NORTH ANNA POWER STATION

*Section 3.4
Reactor Coolant System (RCS)
Book 2*

VOLUME 12
Improved Technical Specifications

MARKUP AND DISCUSSION OF CHANGES

Figure
3.4.16-1

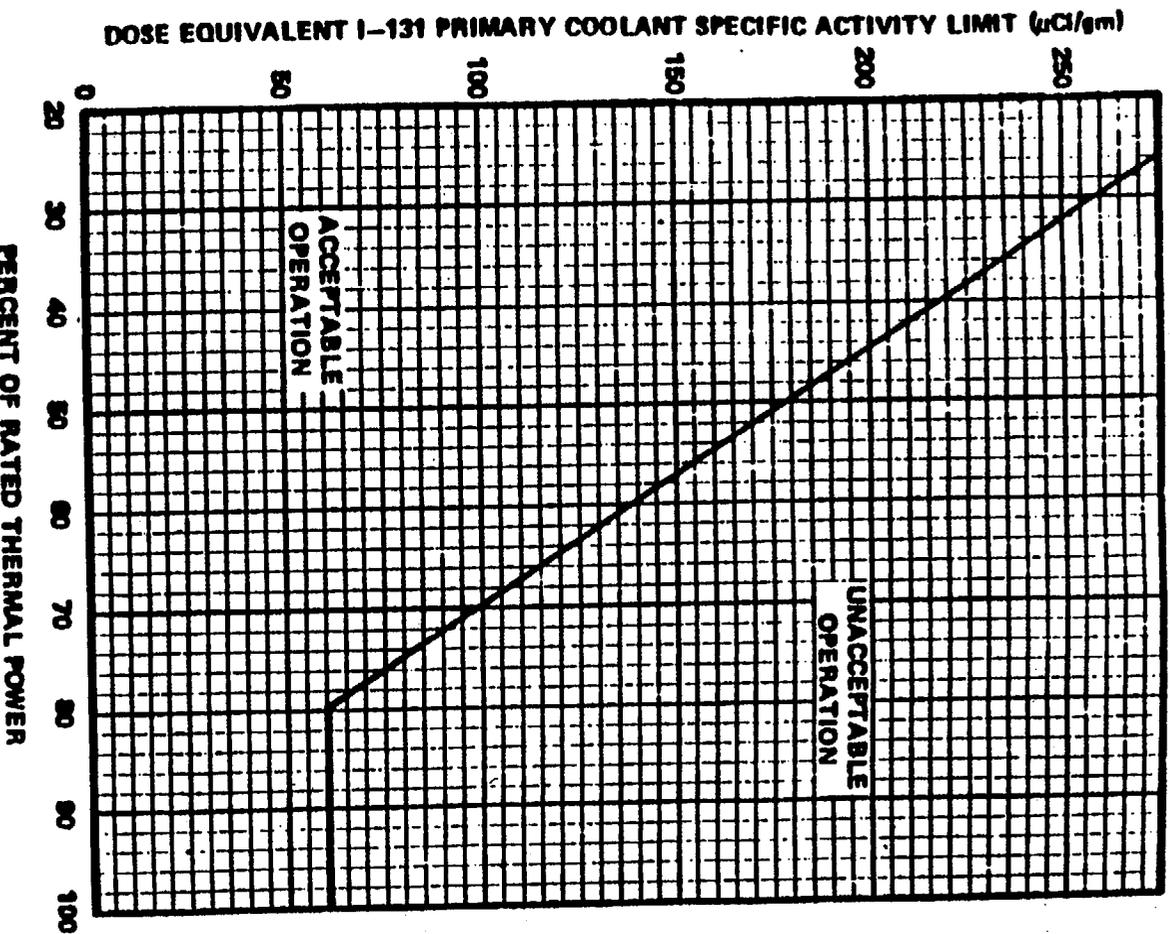
- L.2 (*Category 4 – Relaxation of Required Action*) CTS 3.4.8, Action a., states that when the specific activity of the primary coolant $> 1.0 \mu\text{Ci}/\text{gram}$ DOSE EQUIVALENT I-131 for more than 48 hours during one continuous time interval or exceeding the limit line shown on Figure 3.4-1, be in at least HOT STANDBY with $T_{\text{avg}} < 500 \text{ }^\circ\text{F}$ within 6 hours. ITS 3.4.16, Action A states that with DOSE EQUIVALENT I-131 $> 1.0 \mu\text{Ci}/\text{gm}$, restore the DOSE EQUIVALENT I-131 to within limit within 48 hours. ITS 3.4.16, Action C, states that if the Required Actions and associated Completion Times of Action A are not met, be in MODE 3 with $T_{\text{avg}} < 500 \text{ }^\circ\text{F}$ within 6 hours. ITS 3.4.16, Action A, is modified by a Note which states that LCO 3.0.4 is not applicable. This changes the CTS by allowing MODE changes, currently prohibited by LCO 3.0.4, while relying on ITS Action A.
